Submit an updated drainage report meeting current criteria

## FINAL DRAINAGE REPORT

## FALCON ACRES SUBDIVISION

JPS Project No. 020506

FIGURE A2

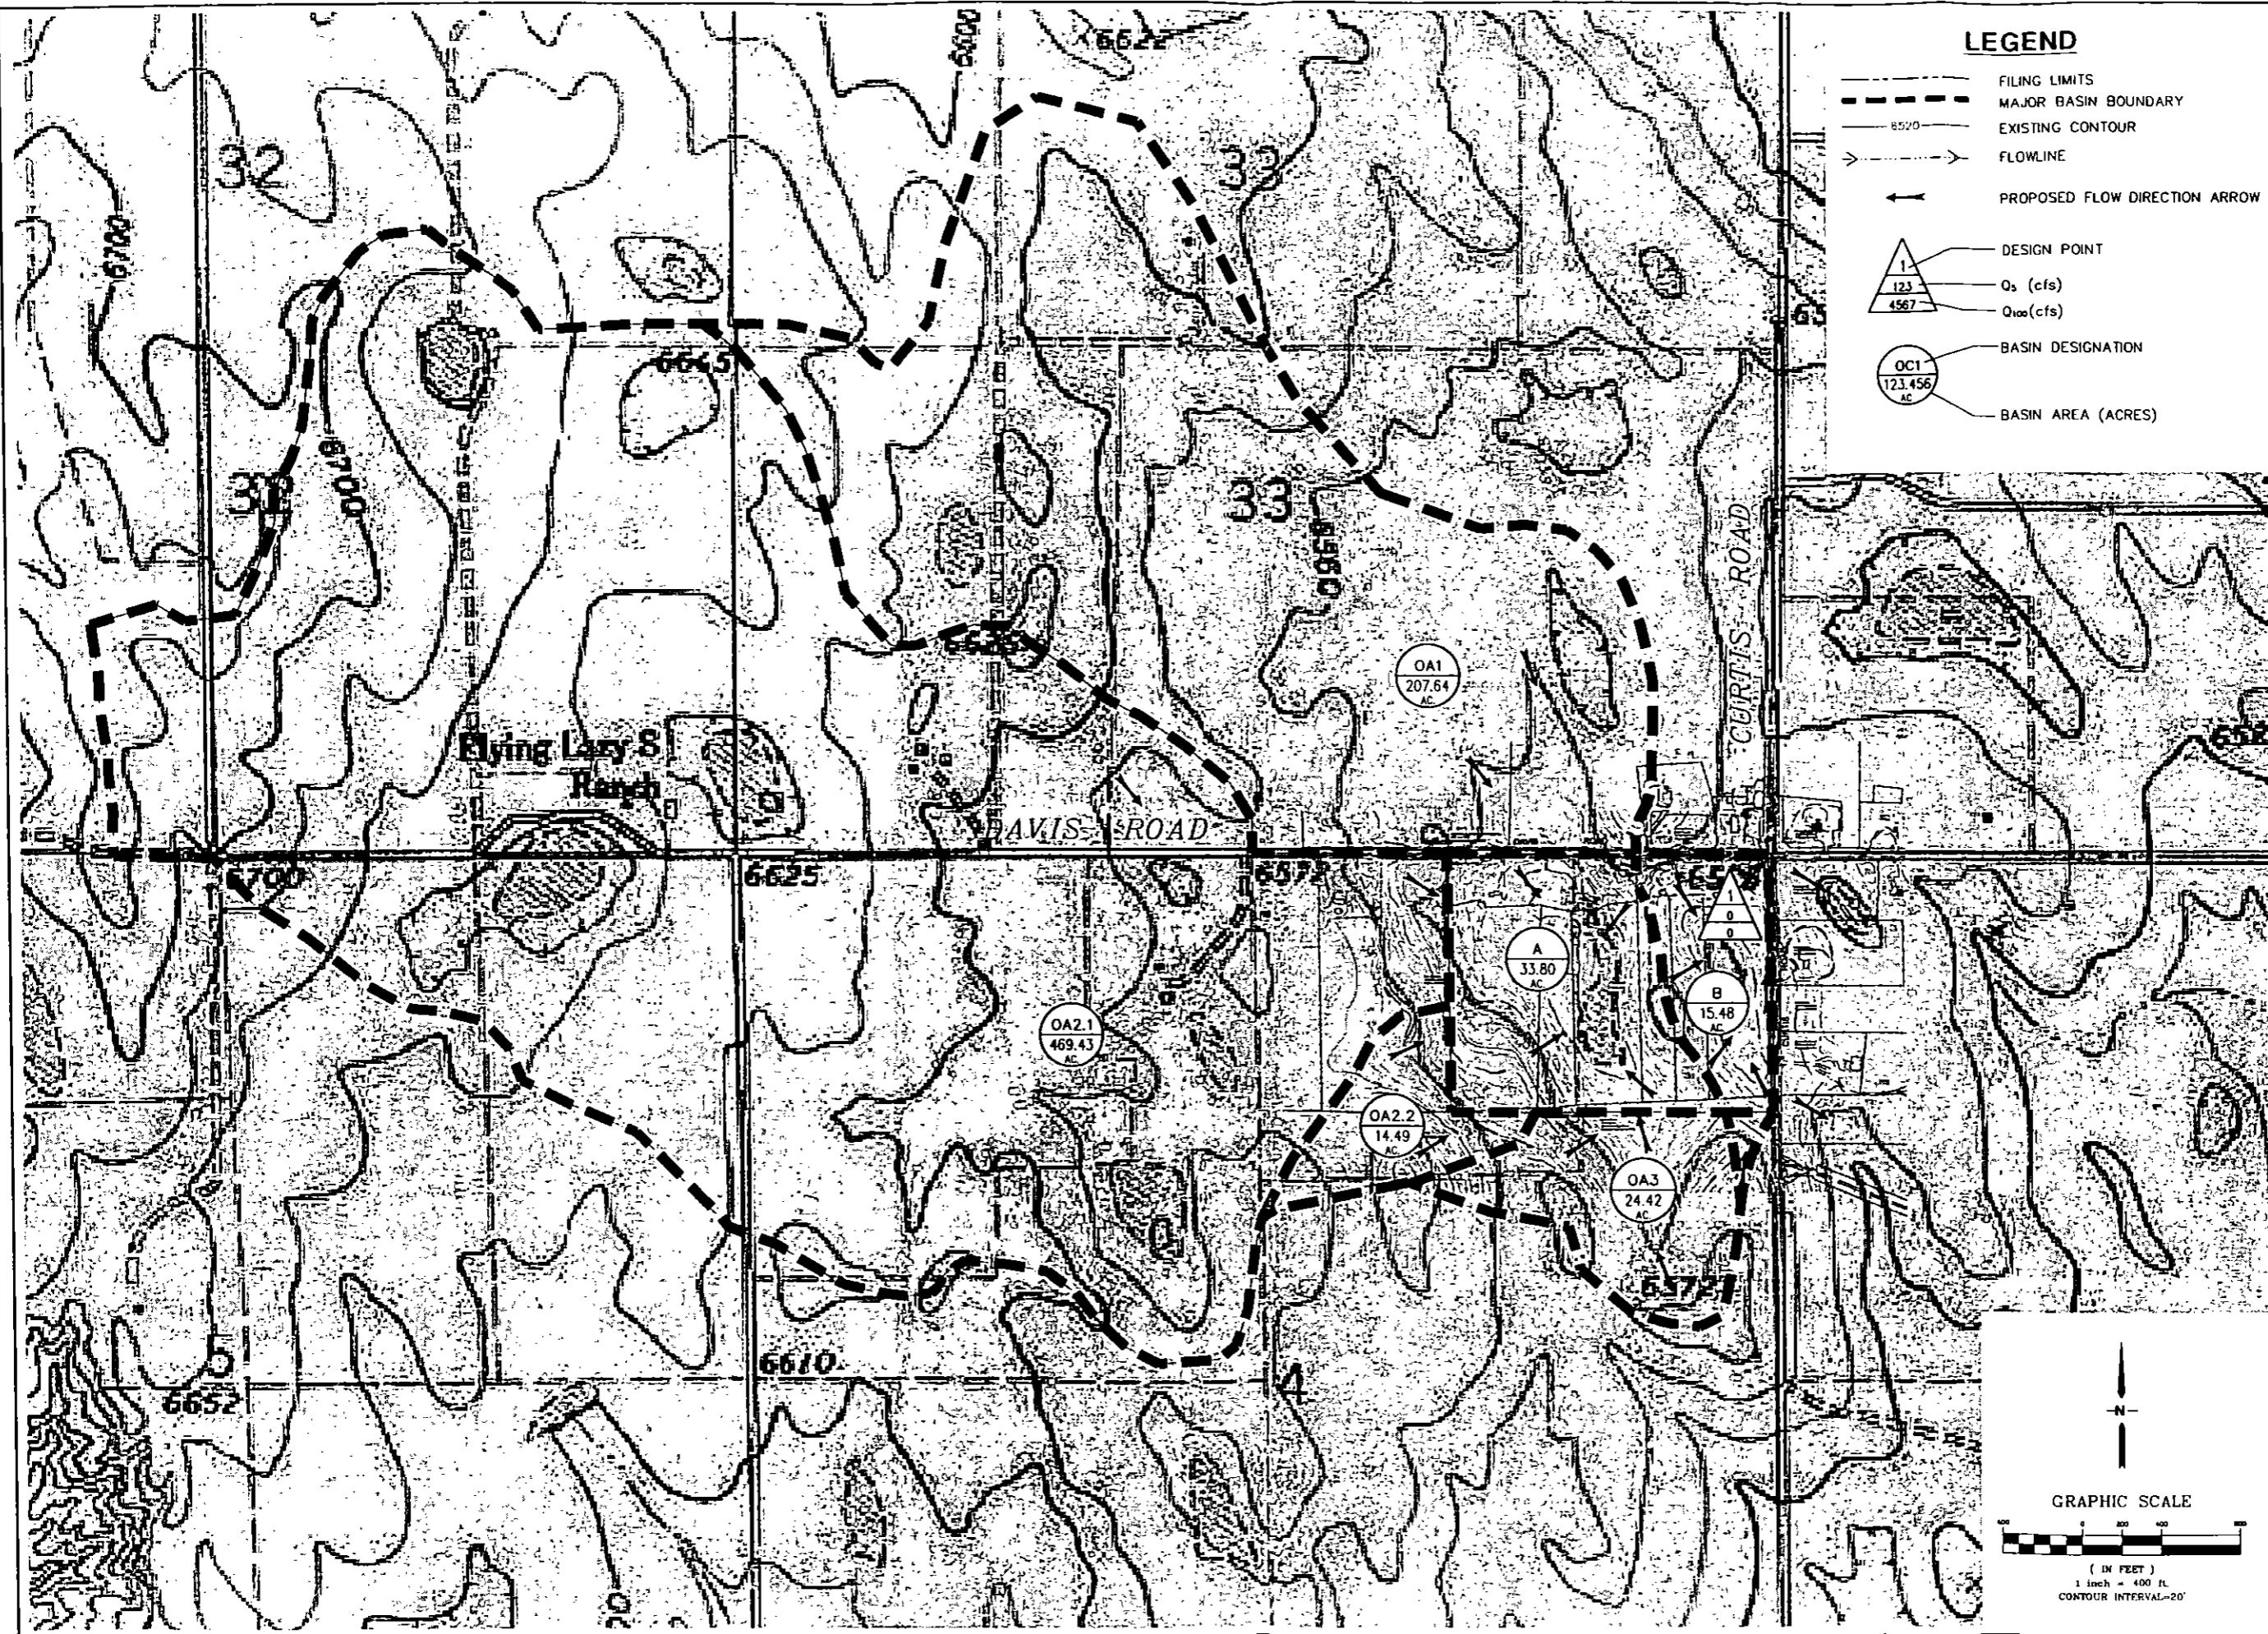
Update to the current effective FIRM

Updated.

FIGURE 3-2. ESTIMATE OF AVERAGE FLOW VELOCITY FOR USE WITH THE RATIONAL FORMULA.

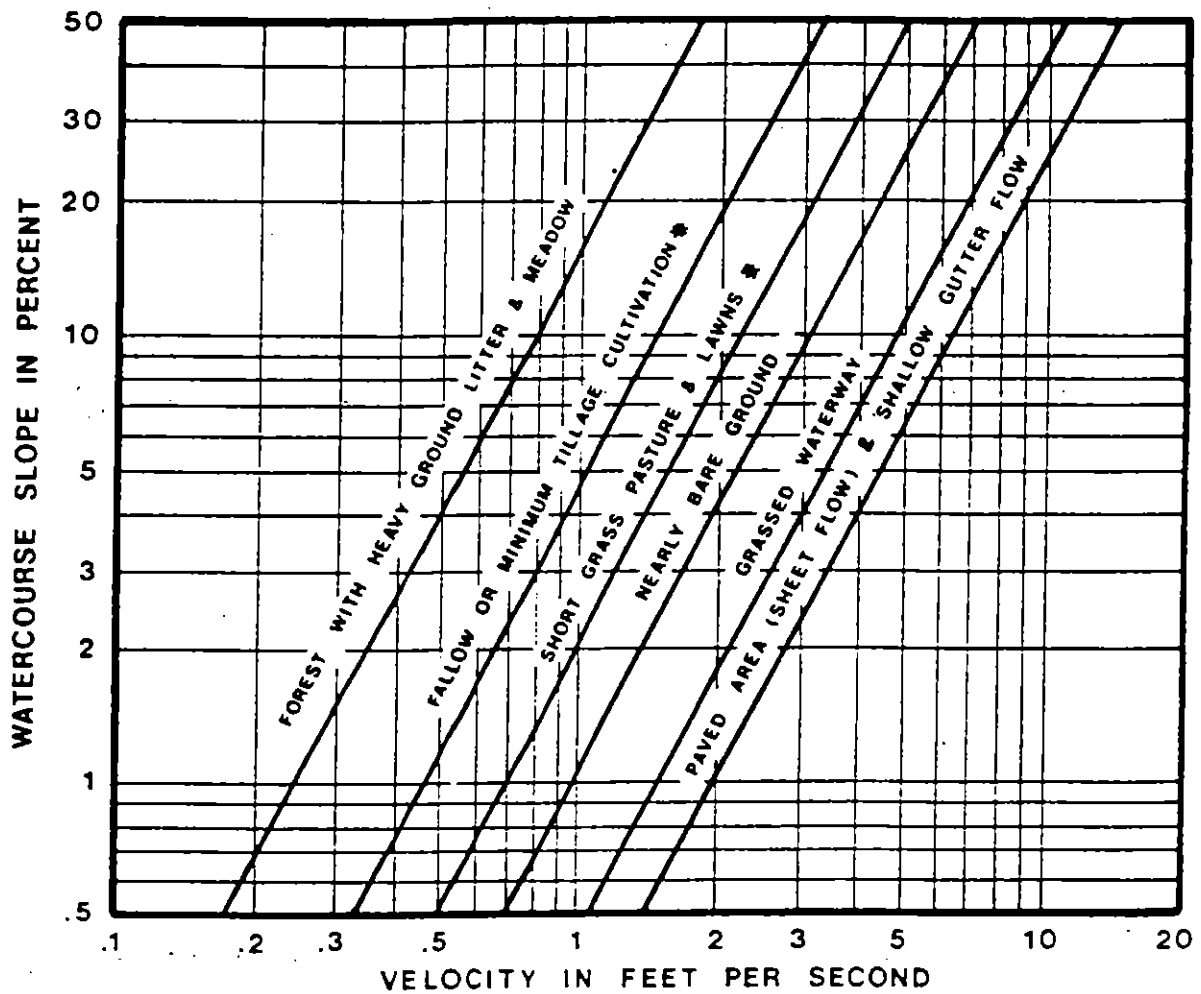
Replace with current criteria

Replaced with criteria from EPC DCM.

FIGURE 3-2. ESTIMATE OF AVERAGE FLOW VELOCITY FOR USE WITH THE RATIONAL FORMULA.

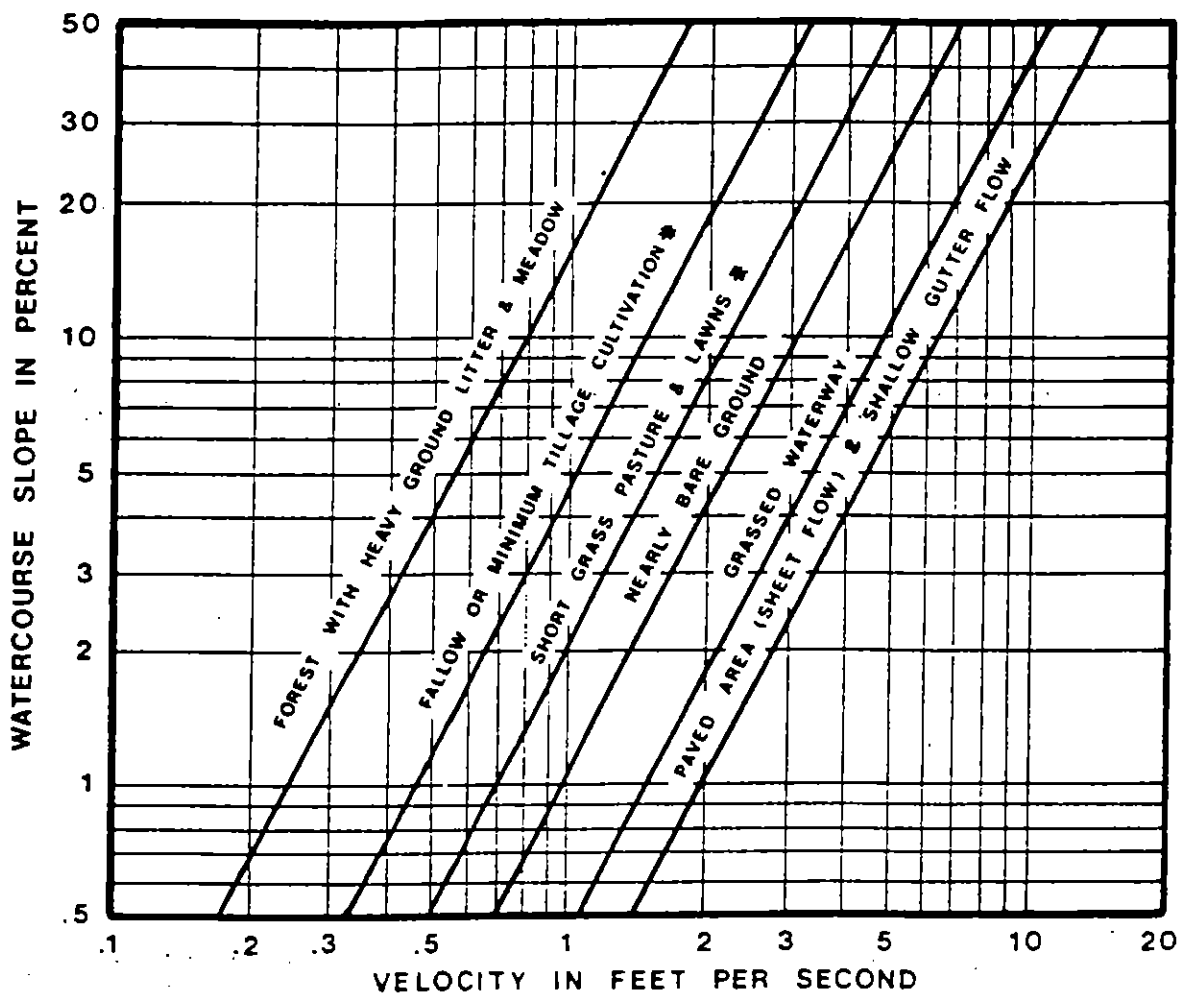
Replace with current criteria

Replaced with criteria from EPC DCM.

| Figure | 5-4 e     |

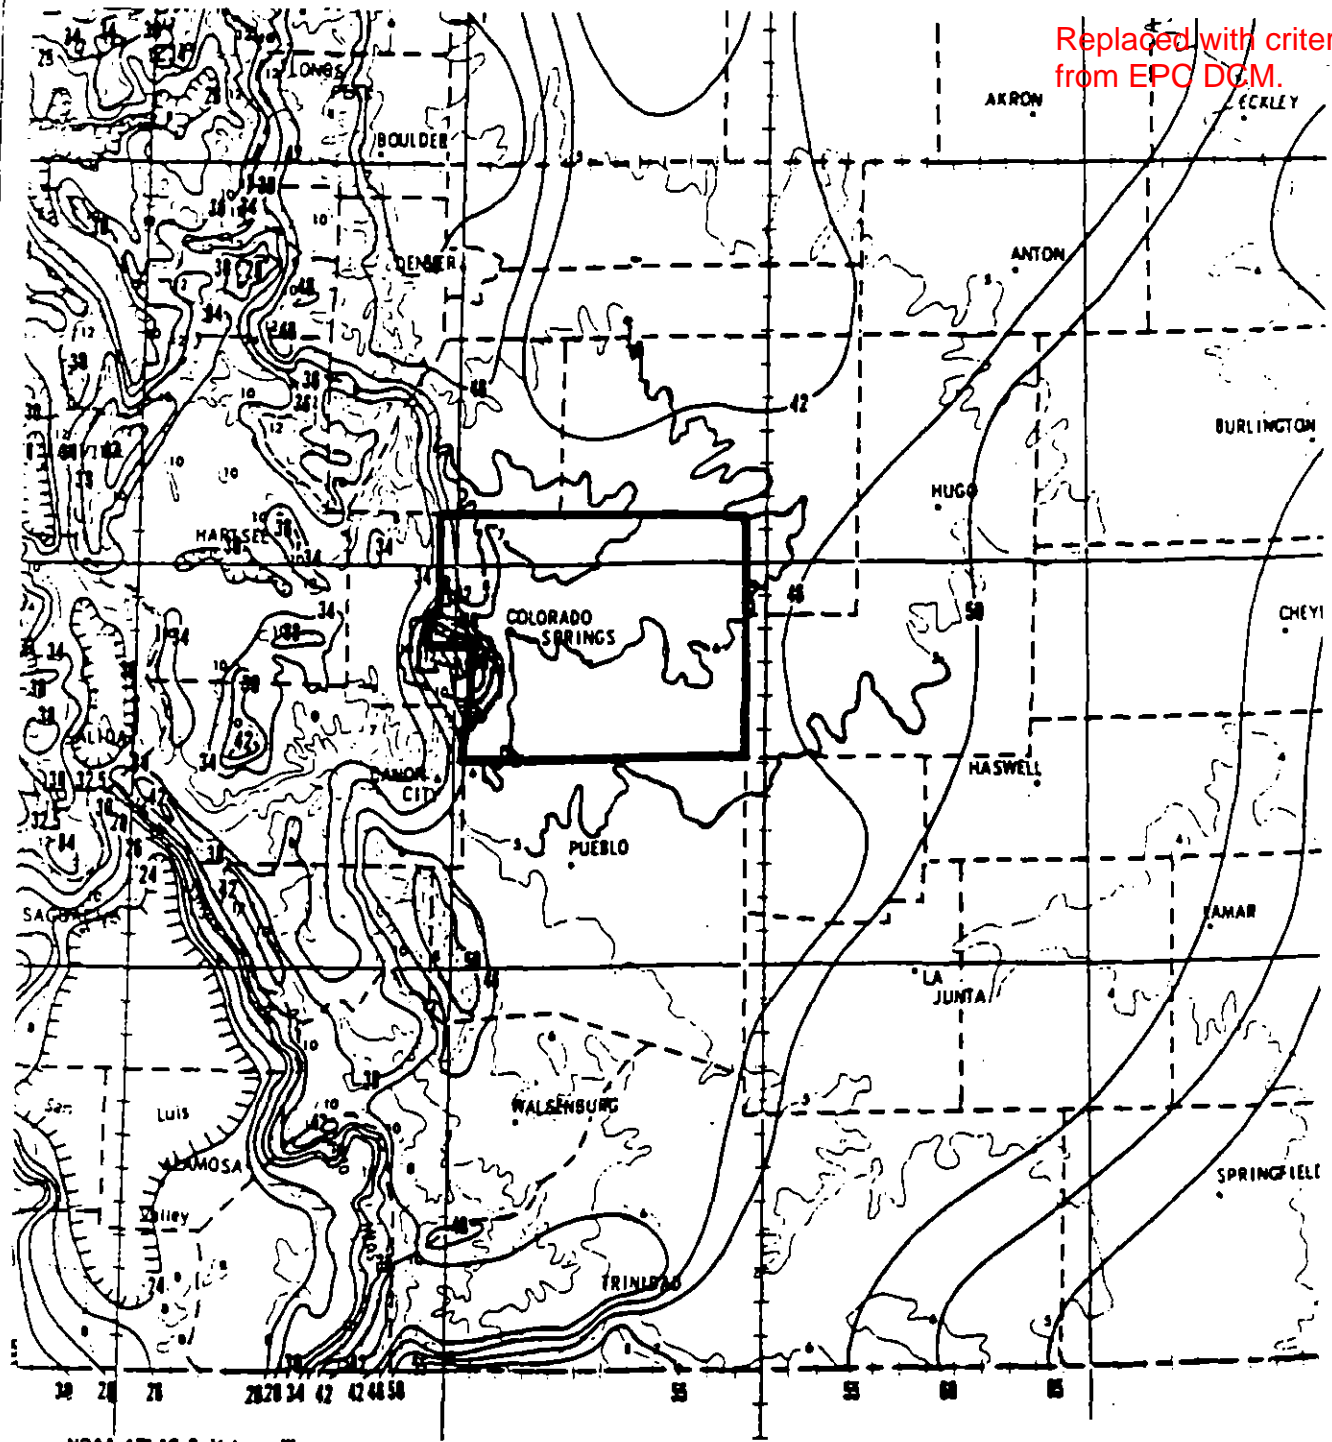
Replace with current criteria

Replaced with criteria from EPC DCM.

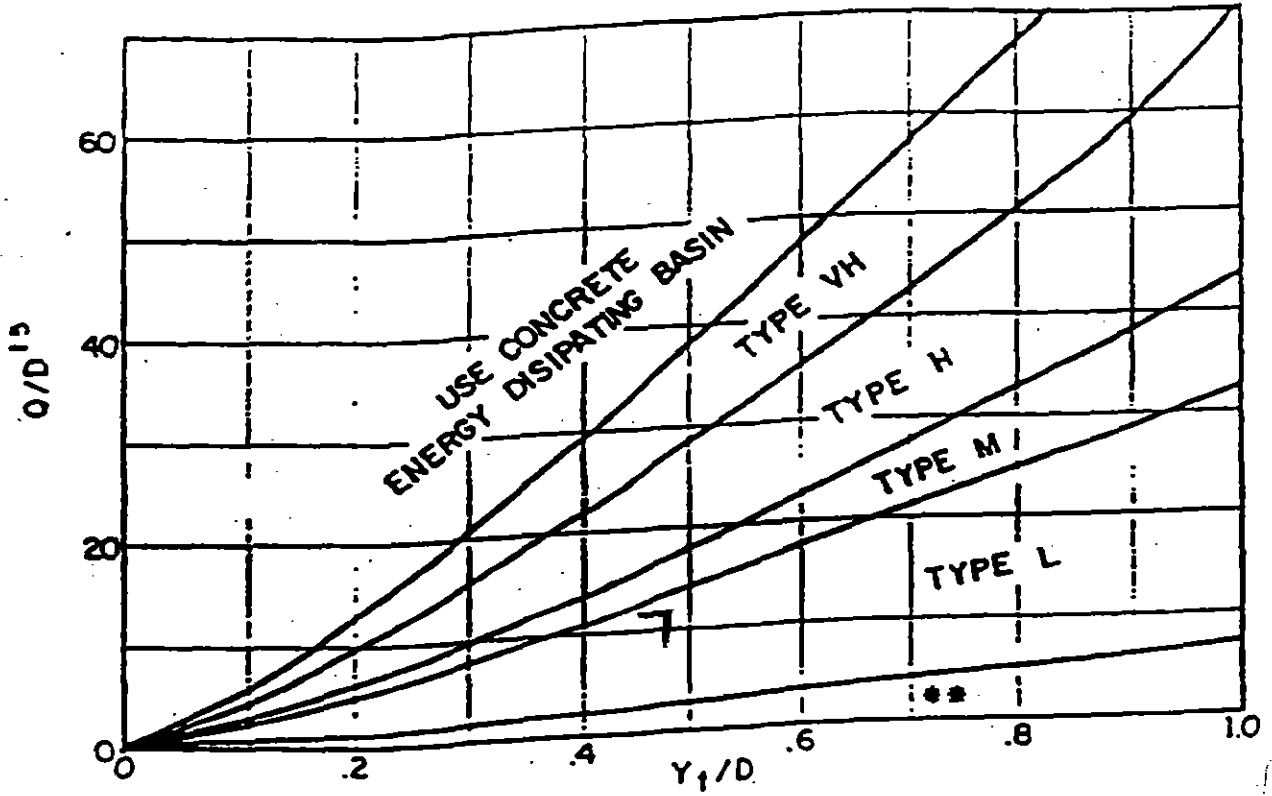
Replace with current figure. typ all
